**NEW YORK STATE THRUWAY AUTHORITY  
DEPARTMENT OF ENGINEERING**

**AMENDMENT NO. 2  
TO**

**CONTRACT TANY 26-17B  
D215020  
REPLACEMENT OF THE PINE HILL ROAD  
BRIDGE OVER I-87 AT MP 47.58,  
REHABILITATION OF I-87 BRIDGE OVER  
SMITH CLOVE ROAD AT MP 47.04,  
AND RESURFACING AND SAFETY IMPROVEMENTS  
ON I-87 BETWEEN MP 46 AND MP 48  
IN THE NEW YORK DIVISION  
OF THE NEW YORK STATE THRUWAY  
IN ORANGE COUNTY**

**IN THE LETTING OF  
JUNE 17, 2026**

**BRIDGE JOINT & HAUNCH RECONSTRUCTION DETAIL**  
N.T.S.  
6SNE-02 & BARRIER REINFORCEMENT NOT SHOWN FOR CLARITY

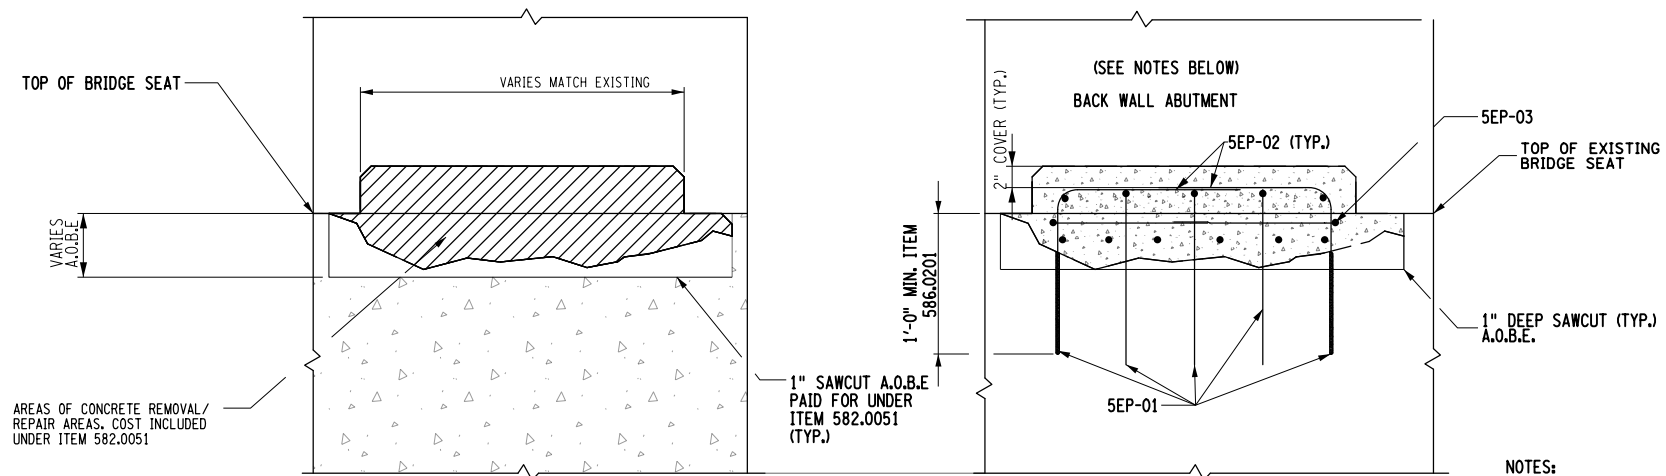
22. **DELETE** Drawing Number MD-01, Sheet 135 of 180, and **SUBSTITUTE** with the attached Drawing Number MD-01, Sheet 135A2 of 180. The Bridge Joint & Haunch Reconstruction Detail has been revised. The previously proposed deck/haunch repair (to have been paid for under Item 557.2119) has been eliminated, along with the callout to replace the bridge joint. Silicone caulking to be paid for under newly added Item 567.51000016, Sealing Existing Bridge Deck Joints, and a bond breaker to be paid for under Item 557.2119 have been added to the detail.

TITLE OF PROJECT I-87 BRIDGE REHABILITATION OVER SMITH CLOVE ROAD (MP 47.04)	CONTRACT NUMBER: TANY 26-17B
LOCATION OF PROJECT VILLAGE OF WOODBURY ORANGE COUNTY BIN 5514279	DATE: 05/21/2025
TITLE OF DRAWING EXISTING BRIDGE PLAN	DRAWING NUMBER: EBP-1

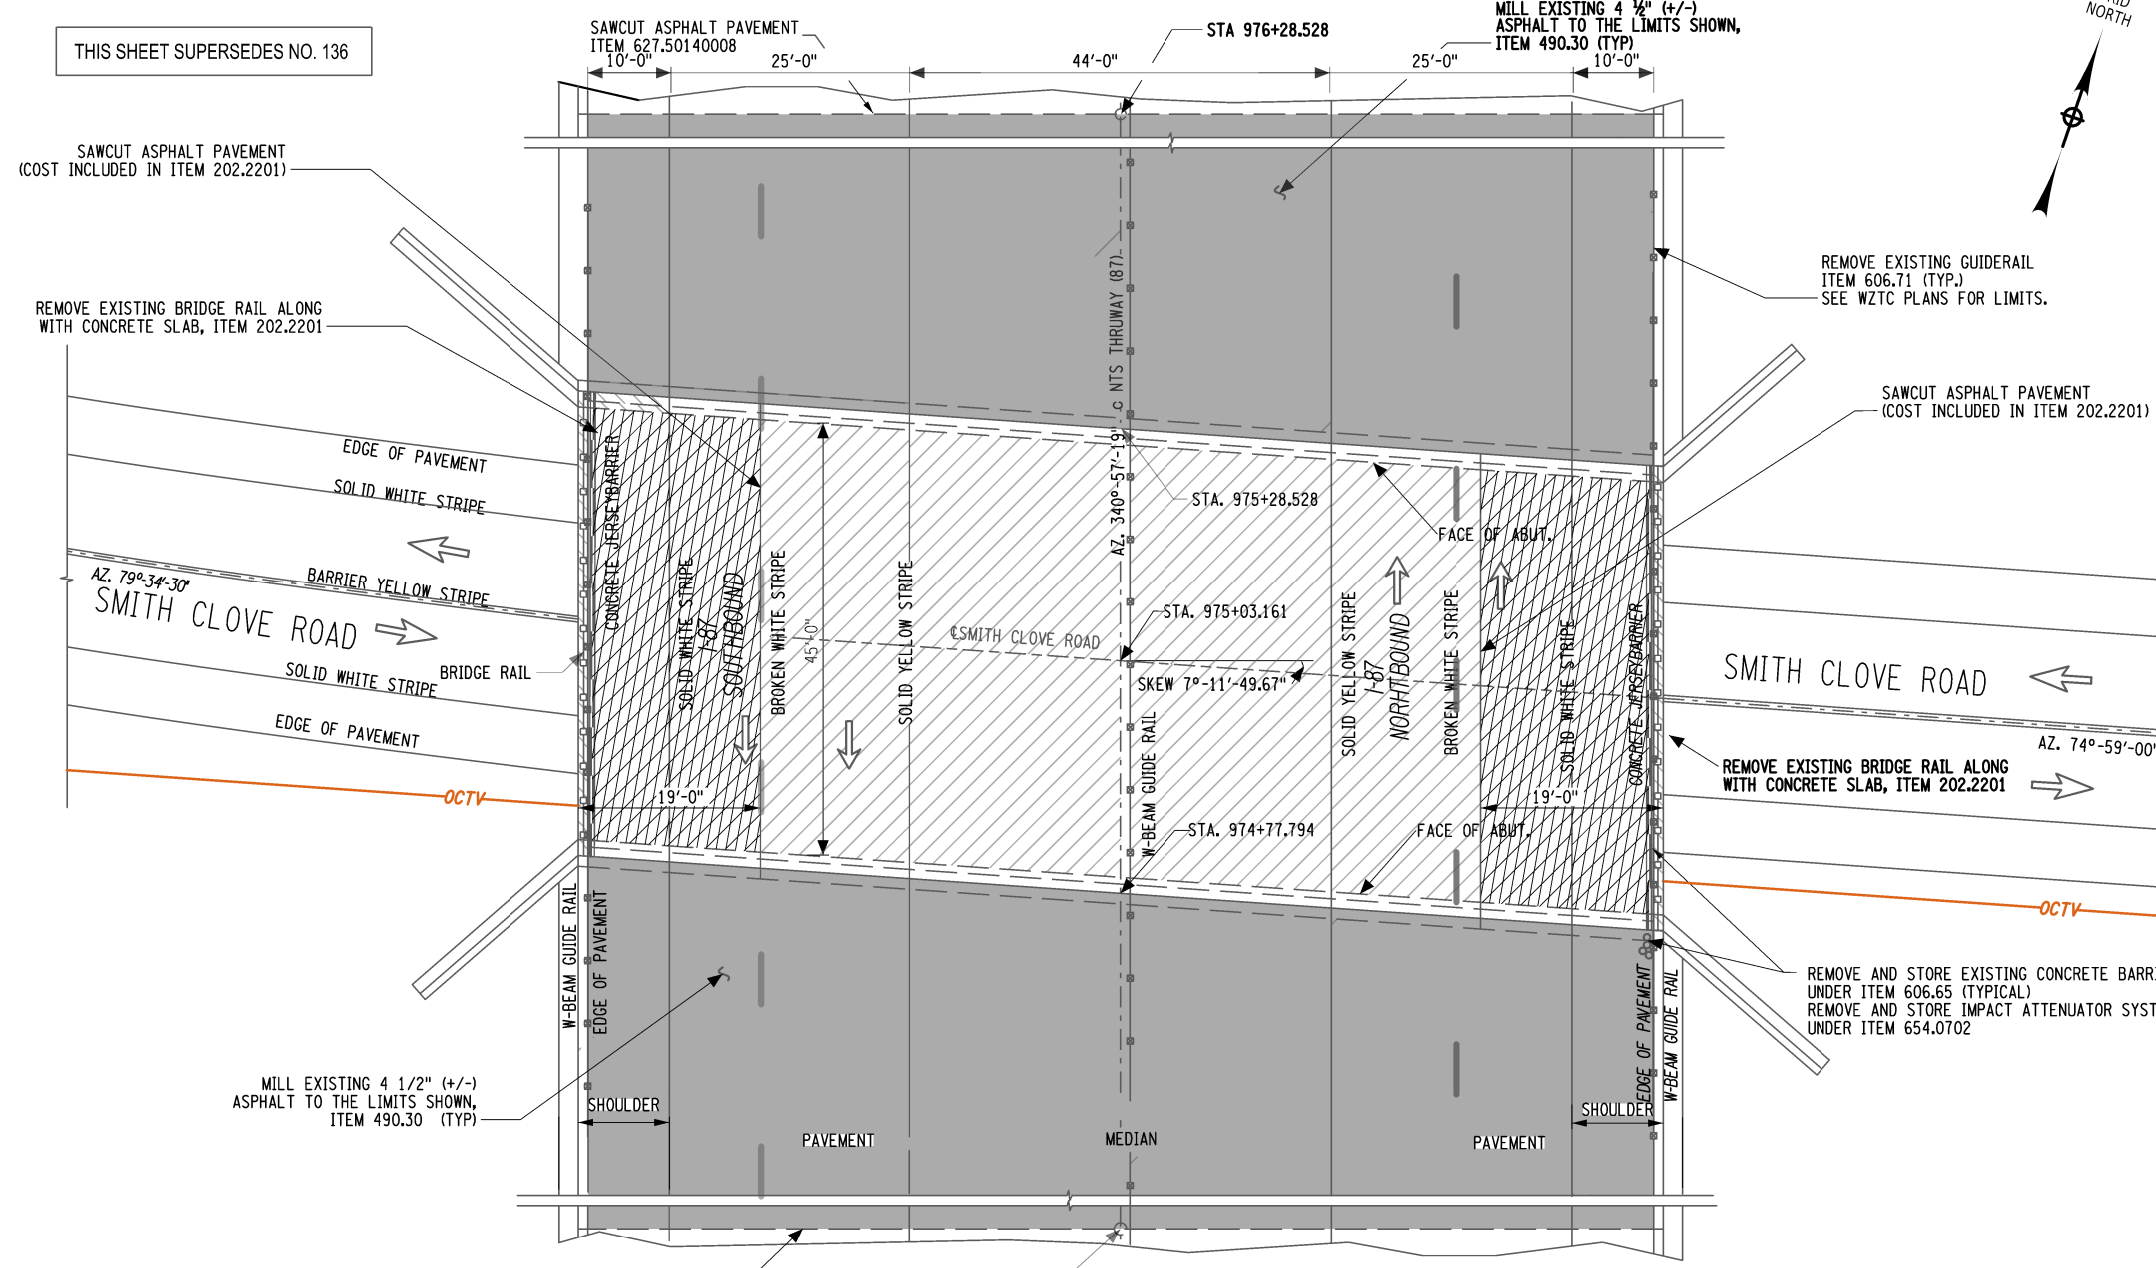
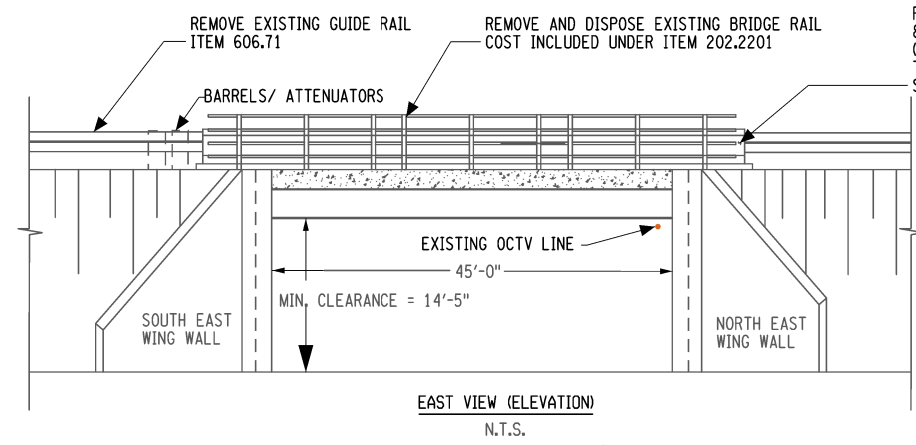
23. **DELETE** Drawing Number EBP-1, Sheet 136 of 180, and **SUBSTITUTE** with the attached Drawing Number EBP-1, Sheet 136A2 of 180. An additional hatching has been added to the Legend and

drawing to indicate the pay limits of Item 202.2201. Removed the miscellaneous cold milling limits from the deck removal limits. Widened the cold milling limits on the (north) end approach to now include the shoulders. A callout to sawcut the pavement has been added at the overhang cut lines at each side of the Plan View, and the costs for the sawcuts at the overhangs are to be included in Item 202.2201.

TITLE OF PROJECT I-87 BRIDGE REHABILITATION OVER SMITH CLOVE ROAD (MP 47.04)	CONTRACT NUMBER: TANY 26-17B
LOCATION OF PROJECT VILLAGE OF WOODBURY ORANGE COUNTY BIN 5514279	DATE: 05/21/2025
TITLE OF DRAWING GENERAL NOTES	DRAWING NUMBER: GN-1

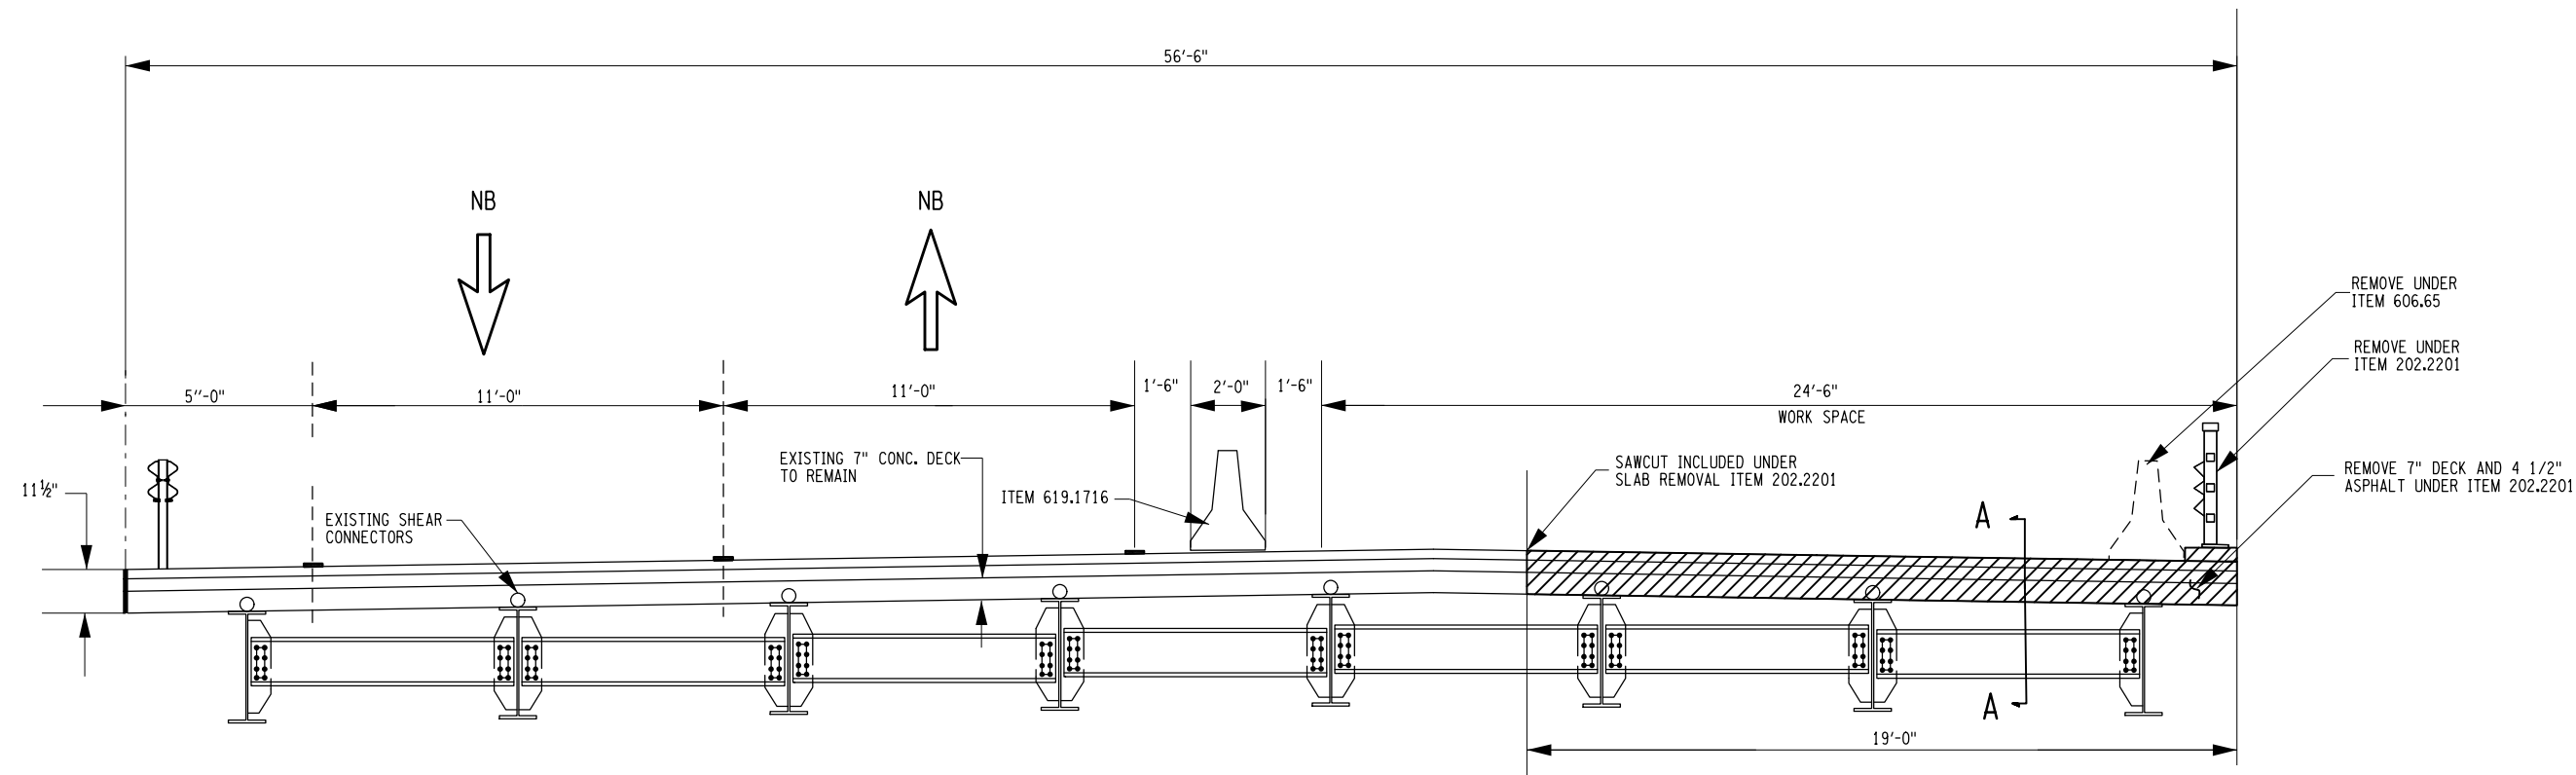
24. **DELETE** Drawing Number GN-1, Sheet 139 of 180, and **SUBSTITUTE** with the attached Drawing Number GN-1, Sheet 139A2 of 180. General Note 13 has been corrected. Superstructure Note 24 has been revised. Superstructure Removal Note 28 has been deleted and the subsequent notes renumbered. Reconstruction Note 49 has been deleted and the subsequent notes renumbered. Previous Reconstruction Note 58 (now 56) has been revised. Asbestos Note 63 (now 61) has been revised to clarify the location of the ACM. Lastly, both Bridge Steel Girder Painting Notes 66 and 67 (now 64 and 65) have been updated.

**NORTH BOUND DECK REMOVAL (DRAWING STAGES 2 & 5)**  
(SOUTH BOUND SIMILAR EXCEPT FOR MIRROR IMAGE)  
N.T.S.

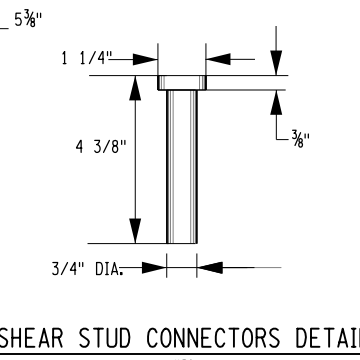
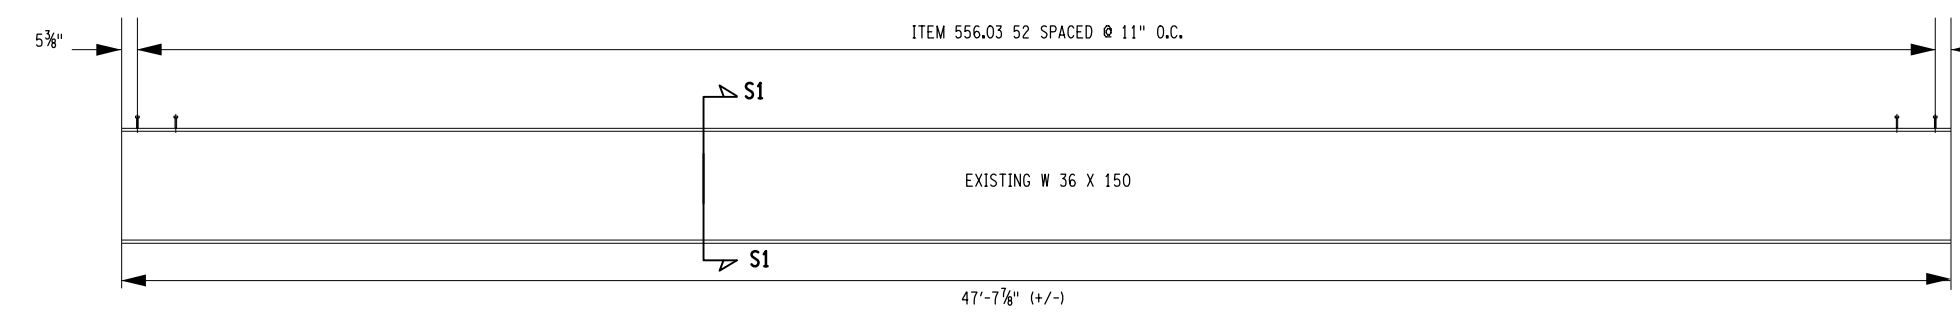
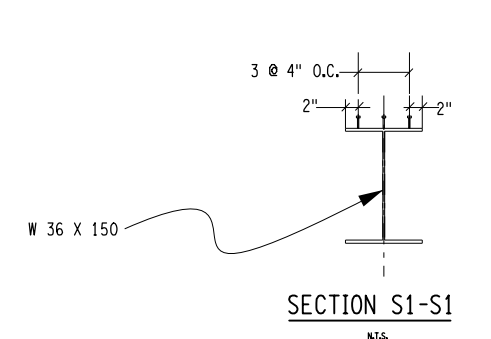
25. **DELETE** Drawing Number DR-1, Sheet 154 of 180, and **SUBSTITUTE** with the attached Drawing Number DR-1, Sheet 154A2 of 180. The 1" sawcut dimension on the Northbound Deck Removal (Drawing Stages 2 & 5) detail has been removed. Note 2 has been revised to reference the corrected Drawing Number **DRD-1**.
